Service Bulletin No. 274

MODEL D Series Coaches	TYPE Field Change Program	SECTION/GROUP 7 – Electrical	DATE Dec. 22, 2006
SUBJECT BOOST CONNECTOR			
CONDITIONS

Ref. NHTSA Recall No.: 06V-481

Figure 1. Existing boost connector.

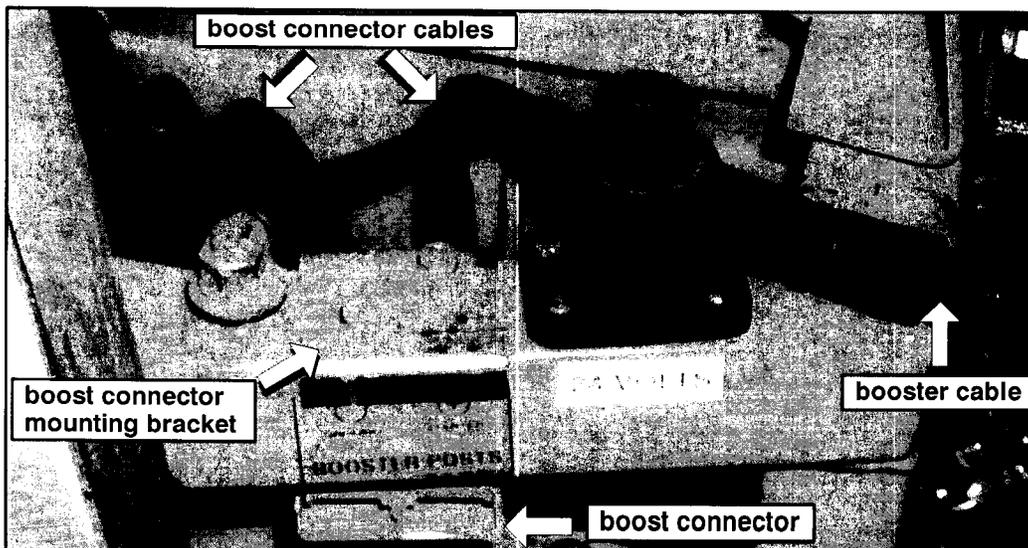
Motor Coach Industries, Inc. ("MCI") has determined that a defect which relates to motor vehicle safety may exist in certain MCI D series coaches that contain a boost connector. MCI has become aware that the boost connector's plastic housing may crack, which can allow the positive and negative leads to come in contact. In rare conditions, this may cause an overheat with arcing, and could result in a thermal event.

2. Open the rear, side service compartment door and locate the boost connector (Figure 1).
3. Clearly identify the existing coach harnesses that are routed to the 24 Volt and Ground booster posts.
4. Remove and retain the nuts, washers, boost connector cables and booster cable from the booster posts.

5. Remove the two capscrews that secure the mounting bracket to the frame. Discard the mounting bracket and the existing boost connector.

MCI is instituting a field change program to replace the boost connectors in all of the coaches listed below. This bulletin describes the procedures for properly disconnecting and replacing the boost connector.

Figure 2.

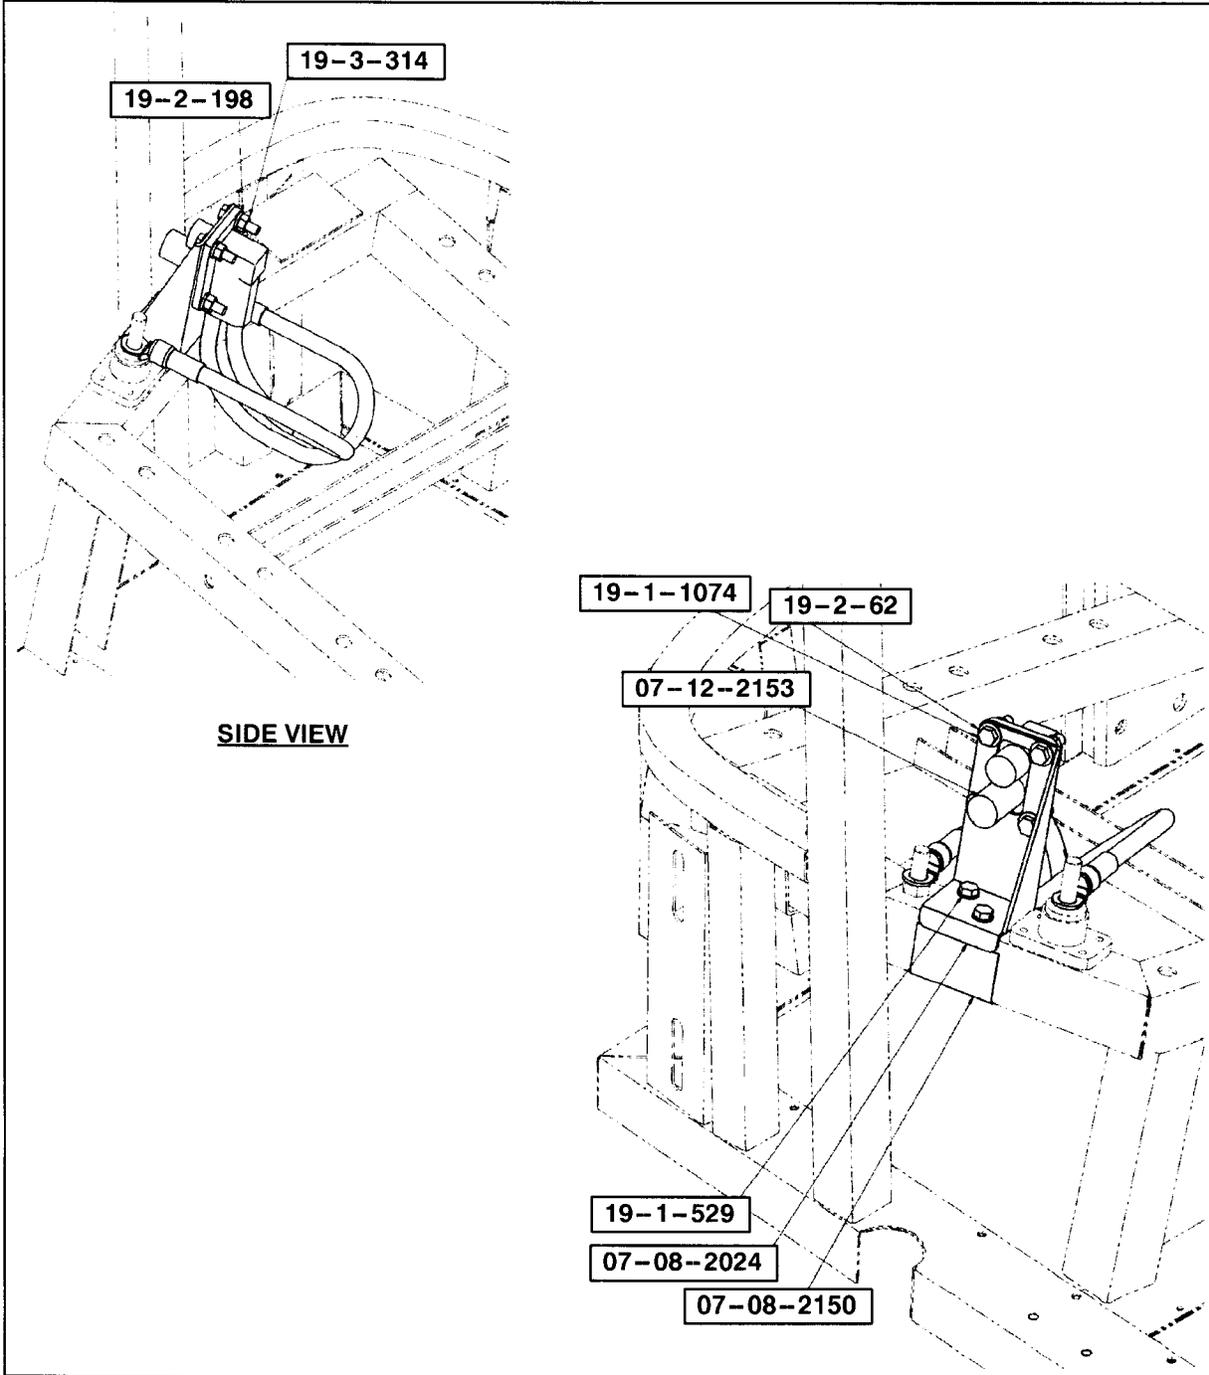
6. Position the mounting bracket (p/n 07-08-2024) on the frame, aligned with existing holes in the frame.
7. Secure the connector assy (p/n 07-12-2153) to the mounting bracket (p/n 07-08-2024) using the hardware provided in the Parts list (p/n 19-1-1074, 19-2-198, 19-2-62 and 19-3-314) (Figures 2 and 3).

Figure 3. Reference photo.

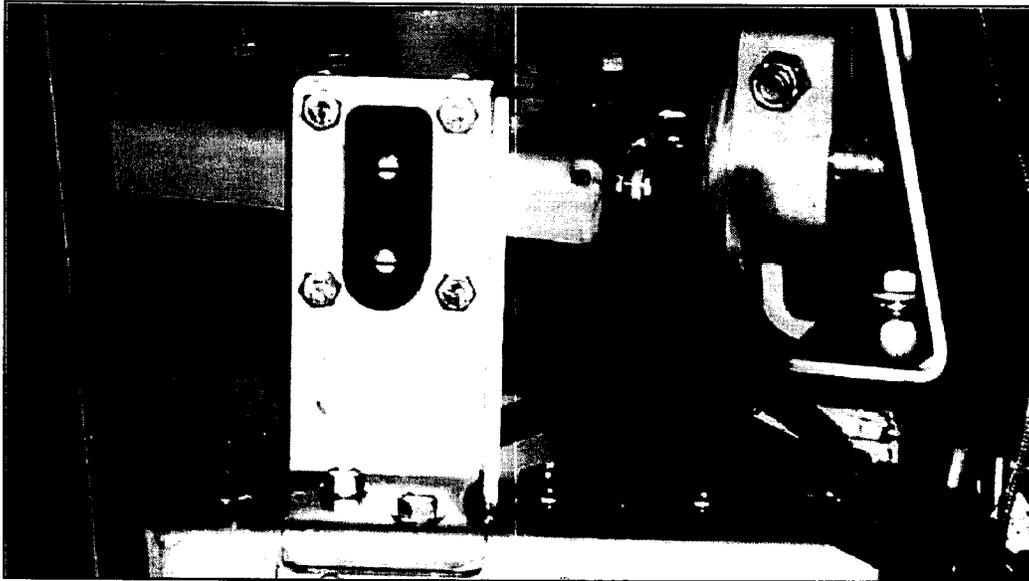
8. Install the booster connector assembly (mounting bracket) to the frame and secure the protective cap (p/n 07-08-2149) using two screws (p/n 19-1-529) (Figures 3 and 4).

Figure 4. Reference photo.

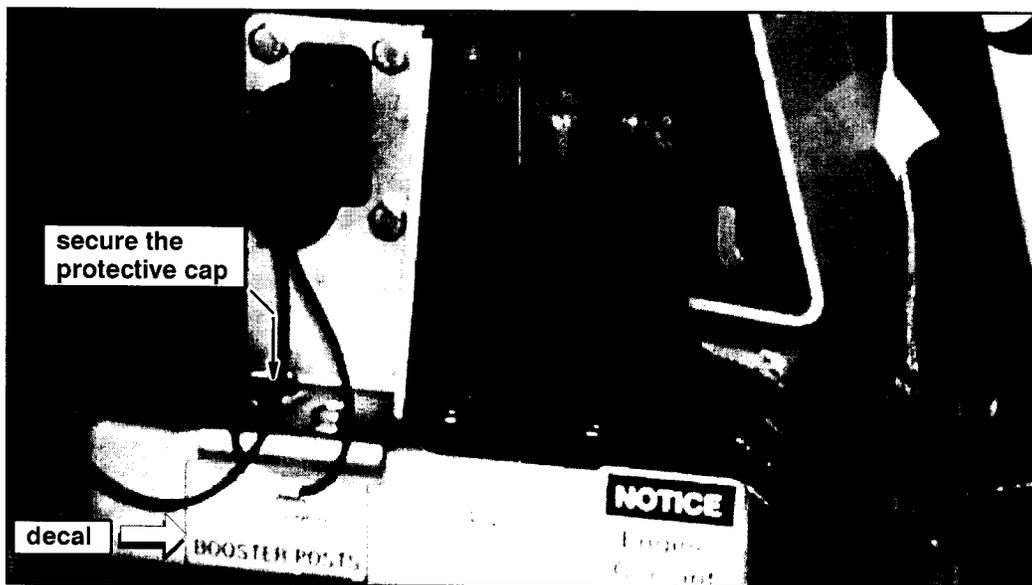
9. Using a clean cloth and an isopropyl alcohol and water mixture, clean the decal application area shown in Figure 4. Apply the booster posts decal (p/n 07-08-2150).
